**TSG-RAN Meeting #6
Nice, France, 13 – 15 December 1999**

TSGRP#6(99)650

Title: Agreed CRs of category "D" (Editorial) to TS 25.331 v3.0.0

Subject: Modification of RRC procedure specifications

Figure 13. ~~Connected mode UE dedicated~~ paging on DCCH

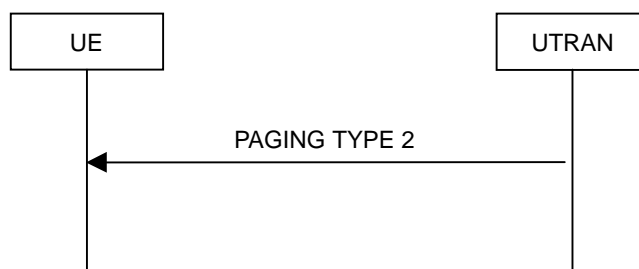
8.1.9 Connected UE dedicated mode ~~paging on DCCH~~
